**SUNDRY NOTICES AND REPORTS ON WELLS**  
*Do not use this form for proposals to drill or to re-enter an abandoned well. Use form 3160-3 (APD) for such proposals.*

8. Well Name and No.  
H B 11 FEDERAL 1

9. API Well No.  
30-015-28693-00-S1

**H B 11 Federal 1  
30-015-28693  
Devon Energy Production Co., LP  
February 28, 2014  
Conditions of Approval**

Well Name: H B 11 FEDERAL 1		Field: CEDAR CANYON	
Location: 1980' FNL & 660' FWL; SEC 11-T24S-R29E		County: EDDY	State: NM
Elevation: 3060' KB; 3034 GL; 26' KB TO GL		Spud Date: 11/30/95	Compl Date: 2/22/96
API#: 30-015-28693	Prepared by: Ronnie Slack	Date: 1/9/14	Rev:

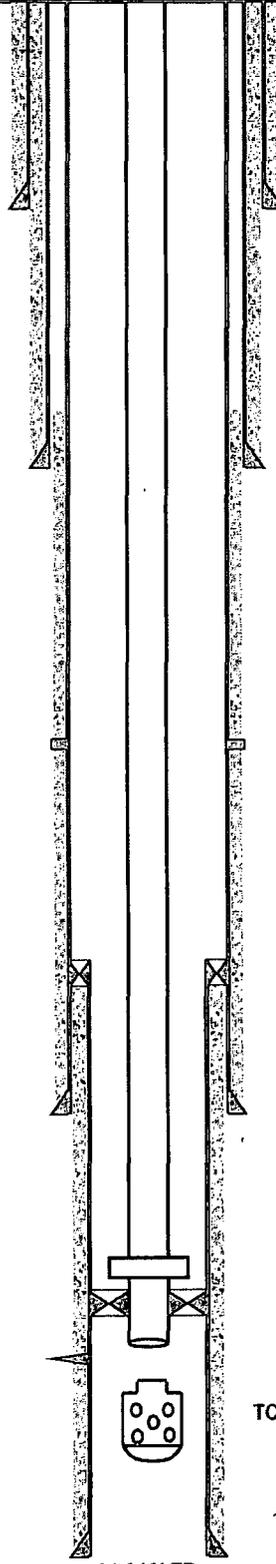
- 1. Operator shall place CIBP at 13,500' and place a minimum of 25 sx class H cement plug on top. Tag required at a minimum depth of 13,260'.**
- 2. Must conduct a casing integrity test to maximum treating pressure before any perforating or fracturing can be done. Submit results to BLM.**
